Appeal of Planning Commission Resolution No. 26-10 Regarding Coastal Development Permit No. 23-034 (33008 Pacific Coast Highway, APN 4473-017-009, Owner Bluff Top 1 LLC, Appellant Mark Mackey) (Continued from September 23, 2026)

Malibu City Council
Special Meeting Agenda

A. Appeal of Planning Commission Resolution No. 26-10 Regarding Coastal Development Permit No. 23-034 (33008 Pacific Coast Highway, APN 4473-017-009, Owner Bluff Top 1 LLC, Appellant Mark Mackey) (Continued from September 23, 2026)

Figure 2: Aerial Map with Blue Line Stream Location

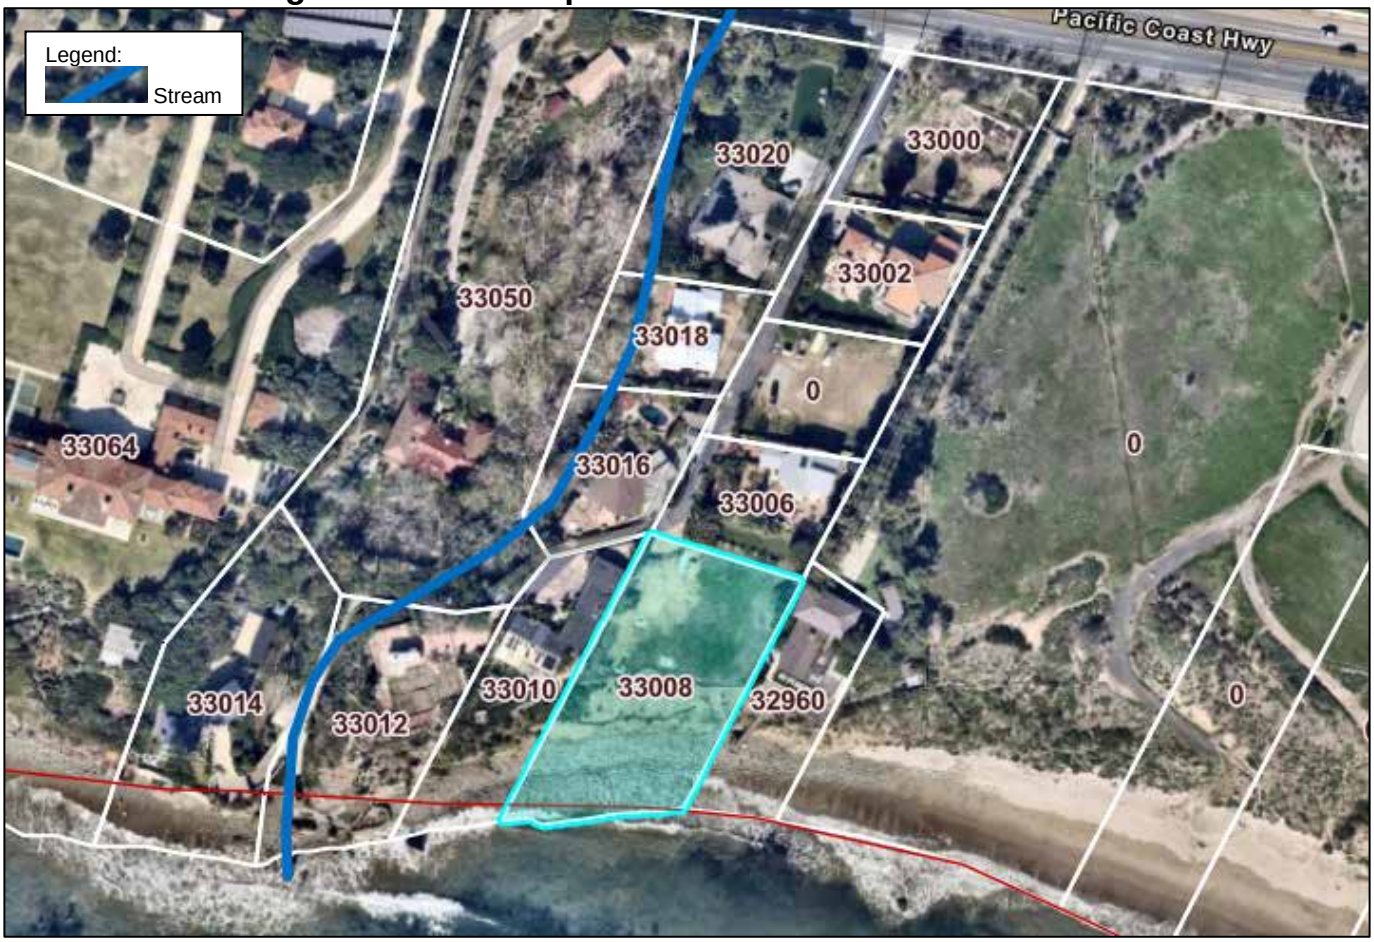
materials and confirmed that the proposed development is located 104 ft. from the mapped blue line stream to the west. It was further confirmed that the project area is located within the existing fuel modification zones of adjacent single-family residences, as shown in Figure 2 below. The figure illustrates that the existing single-family residences and access road are closer to the stream than the proposed project. Nevertheless, the proposed project maintains a 104-ft. setback from the stream, exceeding the required 100-foot buffer. As stated previously, pursuant to Land Use Plan Section 3.1, fuel modification areas required by the LACFD for existing, legal structures do not meet the definition of ESHA. Furthermore, the development is located 100 feet from the stream as required by the LCP, and no new fuel modification encroaches into the ESHA buffer zone.

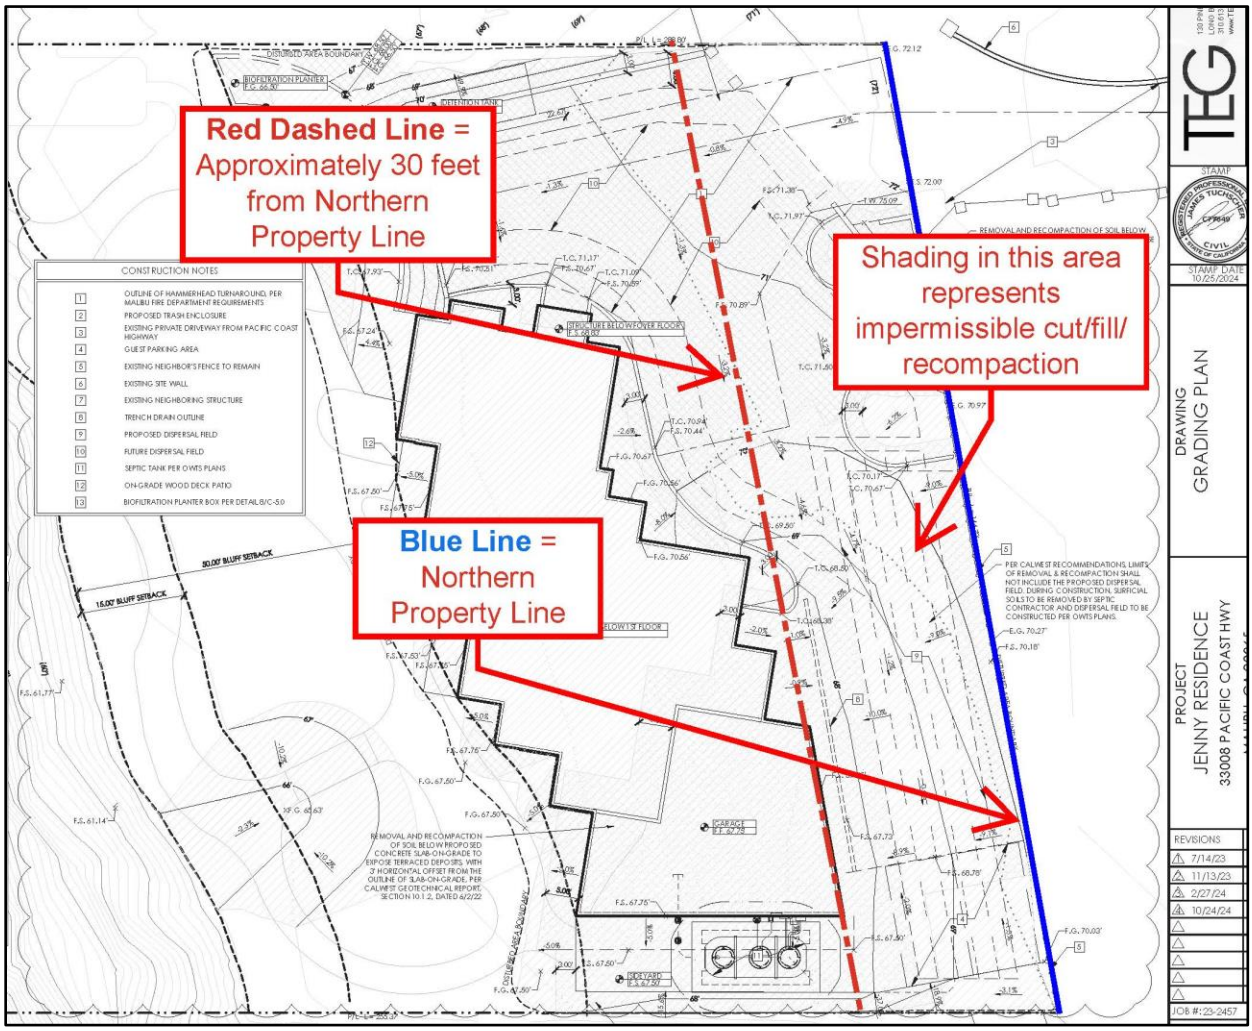
- Finally, the Applicant offers no competent evidence of surrounding fuel-modification zones. Its crudely drawn map in an email memo lacks a legend, scale, or verifiable methodology and cannot serve as substantial evidence to rebut the biological and ESHA findings discussed above.

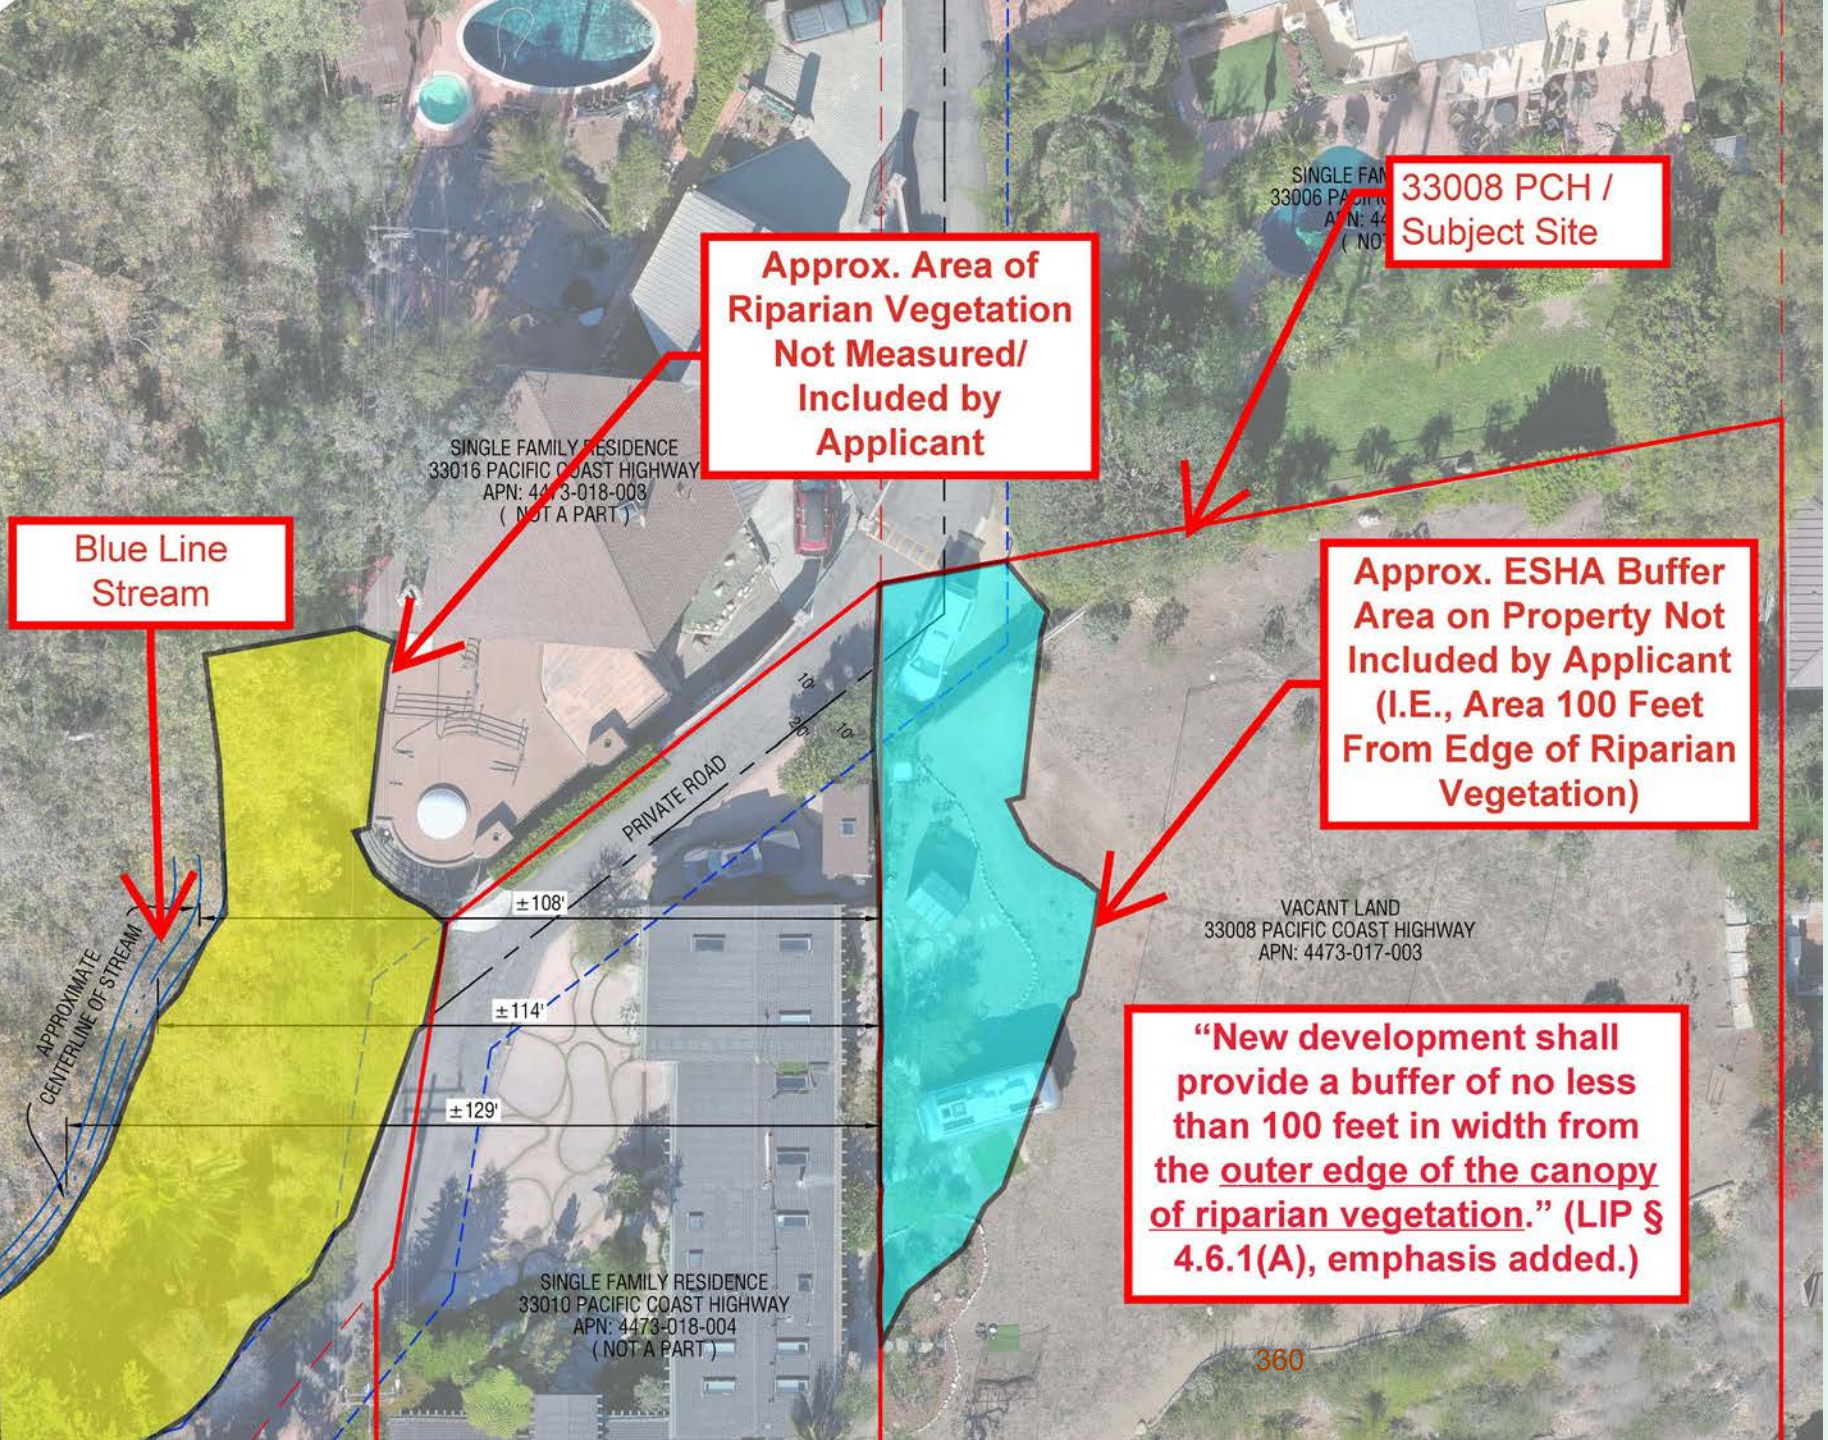
But the LIP requires development to be at least 100 feet from the edge of the riparian vegetation, not the top of the stream bank. The LIP states:
